Client: S.W. Cole Engineering, Inc.**Project:** 93 Washington Avenue**SWCE Project #:** 18-0162**Date:** August 21, 2018**Subject:** Inspection of Field Welds and Bolted Connections**Report:** 001

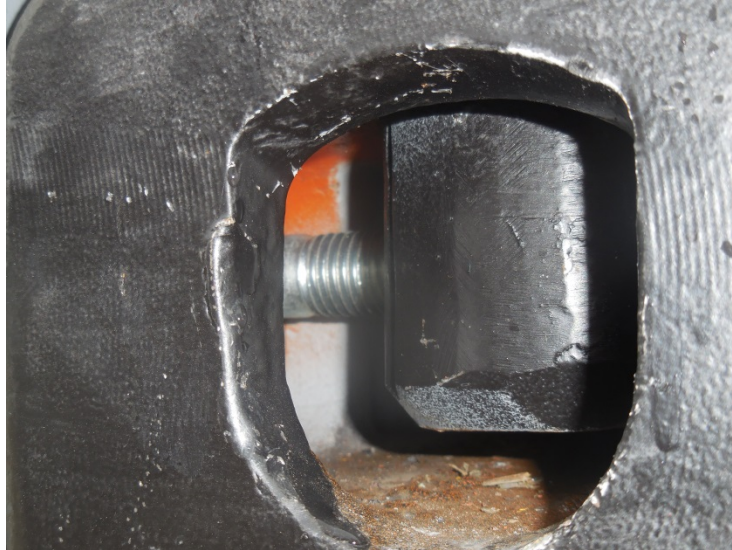
Weld missing on line 4

On line 1 the right support has approximately 2" of sound weld placed in the overhead position
